N4690D-02

Modification Recommended Service Note

N4690D Electronic Calibration Module (ECal)

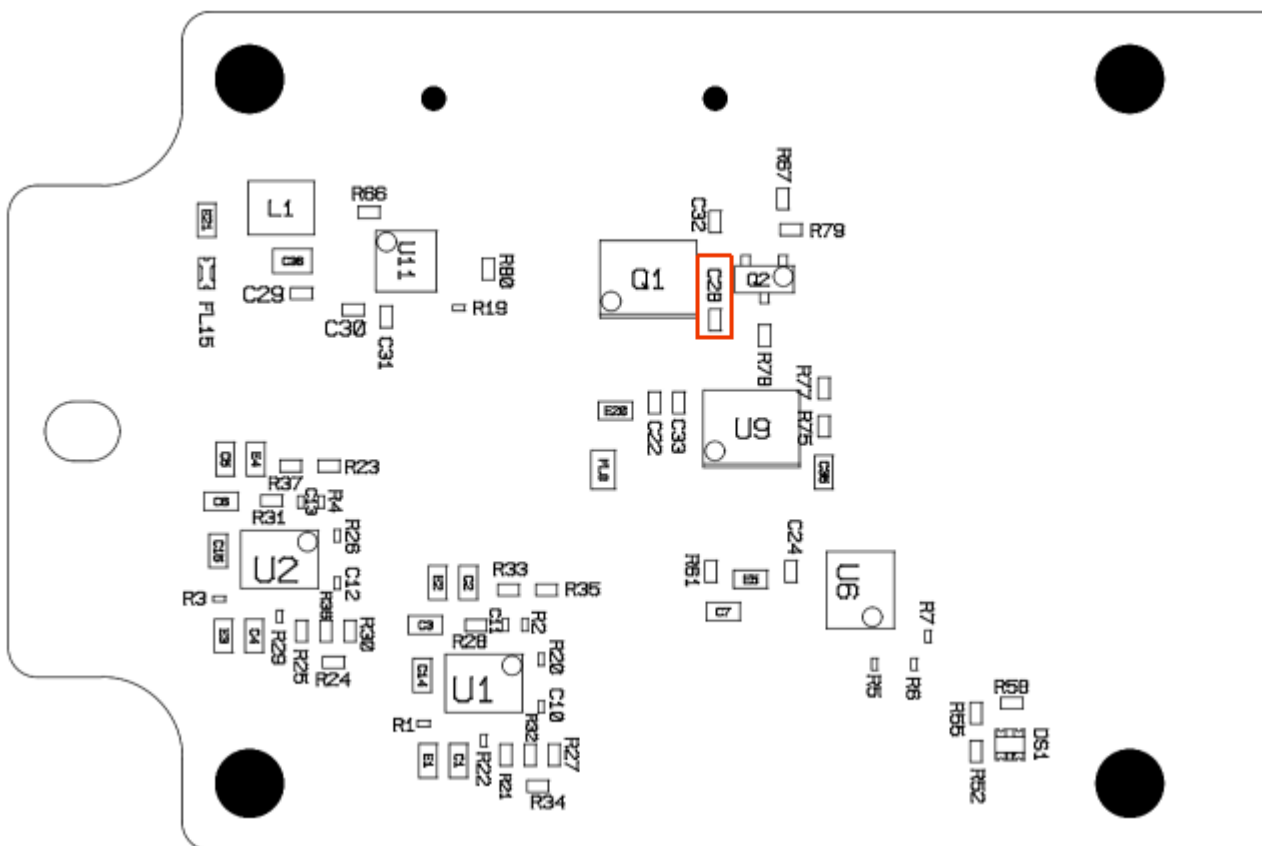
The heater circuit in the N469xD ECal modules was initially designed with a dampening capacitor. It was found in a small number of ECal modules that a resonance can develop in this circuit after the modules is warmed up. This resonance can cause an RF tone between 140 MHz and 150 MHz to be injected onto the signal path.

The dampening capacitor was eliminated in all ECal modules with serial prefix MY5941 and above.

Open the ECal module and remove the N4690-63004 printed circuit board. On this board, locate the C28 capacitor indicated here:

If this capacitor has been removed, no further action is required. Reassemble the ECal module.

If this capacitor exists on this board, this capacitor should be carefully unsoldered and removed, or the N4690-63004 printed circuit assembly should be replaced. Once this is done, reassemble the ECal module.
